COUNTY OF HENRICO VIRGINIA

INTER-OFFICE MEMORANDUM

To:	Planning Office			Subje	ct:	POD2020-000)21:	Richmond Primoid
	Henrico County	Polic	e Division,					
From:	Community Ser	vices	Unit	Date:		December 13	, 202	23
Zonin	D20-00021 g Classification: M-1 ing Case(s):):							
Princi	ole Plan Type (check	one):						
	POD		Site Plan (Minor)		Site	Plan w notice		TUP
	Landscape Plan		Lighting Plan		POE	Revision		CUP
	Master Plan	\boxtimes	Final Construction Plan					
	dary Plan Type (click Landscape Plan ing plans are require		Lighting Plan	OD su	bmiss	ion.		
	co Police Division's I Henrico County Poli Henrico County Poli Henrico Police cann A lighting security p A fencing security p	ce Div ce Div ot cor lan is	rision recommends a ision recommends a mplete our review a required. See Sectio	pprova t this ti on III	al if th	•		ction I are addressed. on is needed.
⊠ Pr	ON I. Address the footide new plans/infootide a response ad	ormat	tion with details to a	addres	item	is noted below.		nt.

Site Specific Comments:

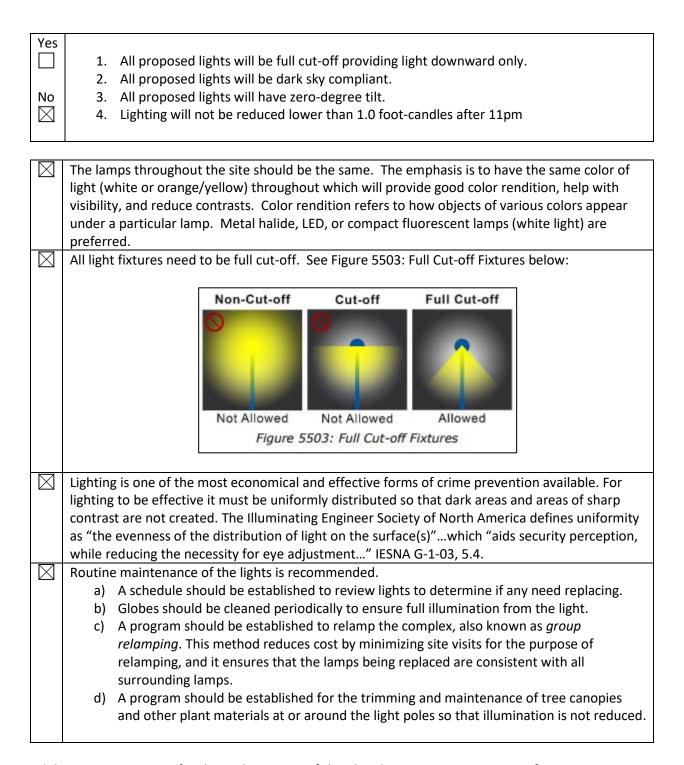
- Provide average photometrics for parking area and proposed sidewalks. See Article 5/Division 5 of the Zoning Ordinance for lighting requirements.
- Provide specification sheets for light fixtures, poles, etc.
- Will any of the fencing or gates be new?
